DART AEROSPACE LTD		Work Order:	98985
Description: Crosstube High Aft (205/212)		Part Number:	D212-664-201
Inspection Dwg: D212-664-241 Rev: D		Page 1 of 1

DART SERVICE INSTRUCTION

D212-664-241/-241B
ASSEMBLY DETAIL

DRAWING NO. D212-664-241	TITLE CROSSTUBE ASSY (205/212 HI AFT)	REV. D	DART AEROSPACE LTD ENGINEERING ORDER		D.E.O. NO. D212-664-241-D-1	SHEET NO. SHEET 1 OF 2	SCALE NTS
DRAWN	CHECKED	MFG. APPR.	APPROVED	DE APPR.			
DATE 11.04.07	DATE 11.04.11	DATE 11.04.12	DATE 11/04/12	DATE 11.04.12

FIGURE 1: SUPPORT INSTALLATION

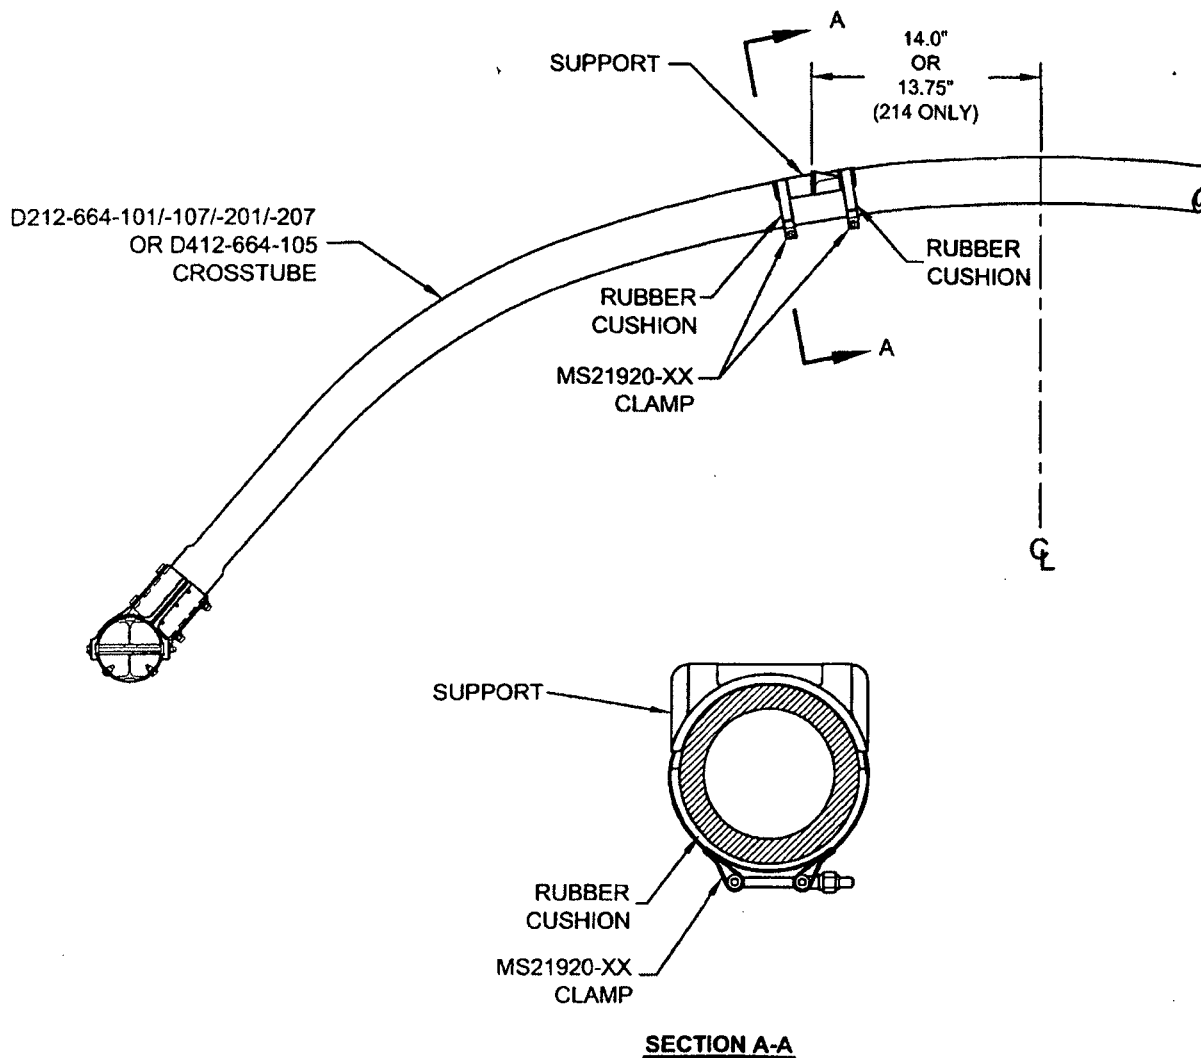
The supports on the following crosstubes are now installed using Proseal instead of Magnobond:

For the crosstubes listed above, section 32.4 of ICA-D212-664 is amended as follows. Use Figure 1 of this service instruction and Figures 32-2 to 32-9 of ICA-D212-664 for further reference. For crosstubes of an earlier change number, it is recommended that if the supports are removed, the supports should be reinstalled using the procedure listed below.

- 32.4.1 Locate the area on the crosstube for installation of support (see Figure 1 of this service instruction). For D212-664-101/-107/-201/-207 and D412-664-105 crosstubes, the outward face of the support tabs should be 14.0" (355mm) from the crosstube center for 204/205/210/412/UH-1 aircraft. For installation on 214B/B-1 aircraft, the outward face of the support tabs should be 13.75" (349mm). Ensure paint finish of crosstube is intact; touch up as required per Chapter 5 (5.3.9) of ICA-D212-664.

- 32.4.2 If present, remove any paint/primer on bottom of supports. Abrade mating surfaces of support and crosstube with 400-grit sandpaper. Saturate a clean cloth with MEK or 4105S Wash'n'Wipe Degreaser or equivalent and wipe until there is no residue.

- 32.4.3 Ensure a layer of 3M Scotch-Weld 2216 B/A Epoxy Adhesive is on the bottom of the support. If required, either apply or touch-up support to have a 0.03" to 0.05" thick layer of adhesive over the entire mating surface. Allow supports to cure for 24 hours.

- 32.4.4 Abrade mating surfaces of support (after cure) and crosstube with 180-grit sandpaper. Saturate a clean cloth with MEK or 4105S Wash'n'Wipe Degreaser or equivalent and wipe until there is no residue.

- 32.4.5 Apply a 0.04" to 0.07" thick layer of Proseal 890 Class B or AMS-S-8802 Class B sealant underneath applicable support and install support as shown in Figure 1 of this service instruction.

- 32.4.6 Install the clamps opposite to crosstube support as shown in section A-A of Figure 1. Install rubber cushions underneath each clamp around the bottom circumference of the crosstube up to the crosstube centerline. Torque clamps 80-100 in-lb (9.0-11.3 Nm). It is acceptable to use smaller or larger sized MS21920-XX clamps than those listed in ICA-D212-664, ensure that after torquing the clamps per this instruction, the nuts are in safety but not bottomed out

- 32.4.7 Prior to installing crosstube on aircraft, allow supports to cure for 72 hours and recheck torque on clamps.

**D212-664-241/-241B
ASSEMBLY DETAIL**

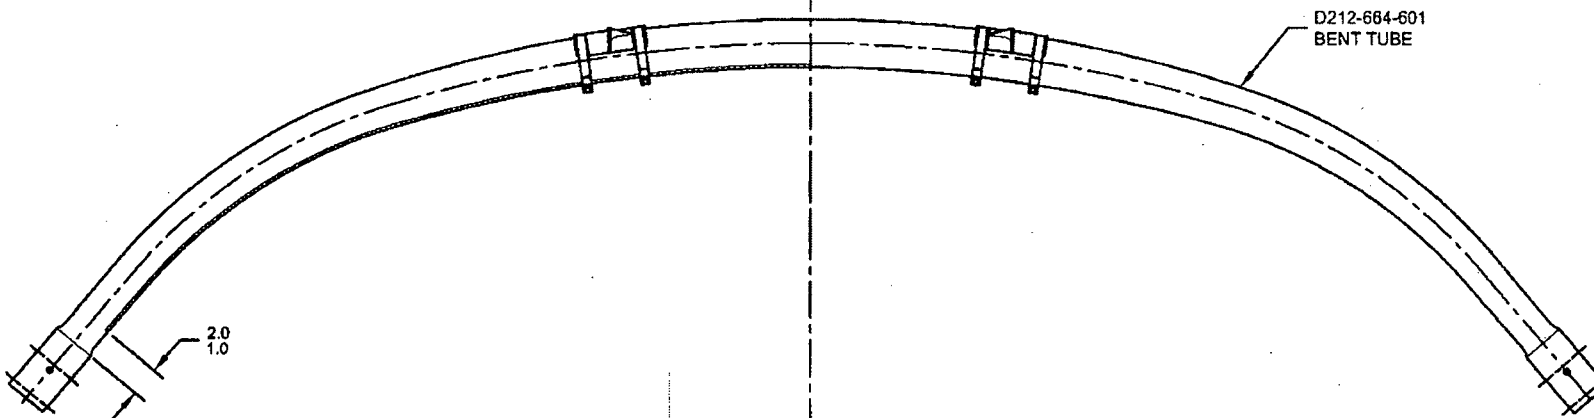
ADD AN INSPECTION WINDOW TO UNDERSIDE OF CROSSTUBE.

NOTES 2 OF SHEET 1 IS AMENDED AS FOLLOWS:

- 2) FINISH: CHEMICAL CONVERSION COAT PER DART QSI 005 4.1
PRIME INSIDE AND OUTSIDE PER DART QSI 005 4.2
MASK UNDERSIDE OF CROSSTUBE AS SHOWN (HATCHED AREA) AND
PAINT OUTSIDE PER DART QSI 005 4.2
REMOVE MASKING AND APPLY CLEAR COAT

MASK AREA PRIOR TO PAINTING,
REMOVE MASKING AFTER PAINT
AND APPLY CLEAR COAT

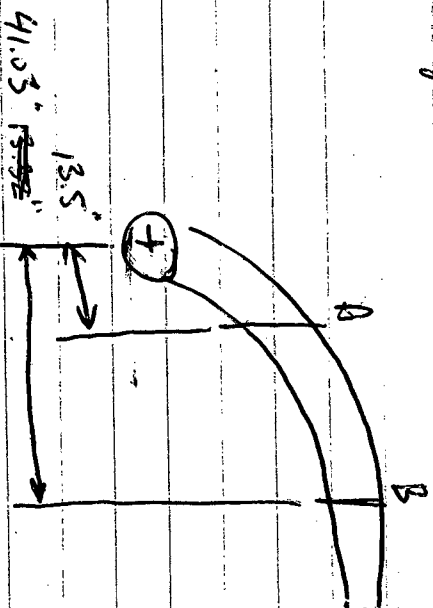
REPLACE MAGNOBOND WITH PROSEAL.

NOTE 12 & 15, SHEET 1 IS AMENDED AS FOLLOWS:

- 12) TO INSTALL D2940-1 SUPPORT: ABRASE MATING SURFACE OF SUPPORT AND CROSSTUBE WITH 180-GRIT SANDPAPER AND REMOVE RESIDUE WITH MEK (OR EQUIVALENT). APPLY A 0.04" TO 0.07" THICK LAYER OF PROSEAL 890 CLASS B-2 (OR AMS-S-8802 CLASS B-2) SEALANT TO MATING SURFACE OF SUPPORT.
- 15) TORQUE CLAMPS 80 TO 100 IN-LB. ENSURE AT LEAST 1.5 THREADS SHOWING IN SAFETY AND THAT NUT HAS NOT BOTTOMED-OUT AFTER TORQUING. **PRIOR TO PACKAGING, RE-CHECK TORQUE ON CLAMPS AFTER PROSEAL 890 SEALANT HAS CURED FOR 72 HOURS.**

- 12) INSTALL D2940-1 SUPPORT USING 0.03" TO 0.06" THICK LAYER OF MAGNOBOND 6398 TO THE SURFACE OF D2940-1 THAT WILL BE IN CONTACT WITH THE CROSSTUBE PER QSI 015. LET CURE FOR 12 HOURS AFTER INSTALLATION AND PRIOR TO PACKAGING.
- 15) TORQUE CLAMPS 80 TO 100 IN-LB. ENSURE AT LEAST 1.5 THREADS SHOWING IN SAFETY AND THAT NUT HAS NOT BOTTOMED-OUT AFTER TORQUING.
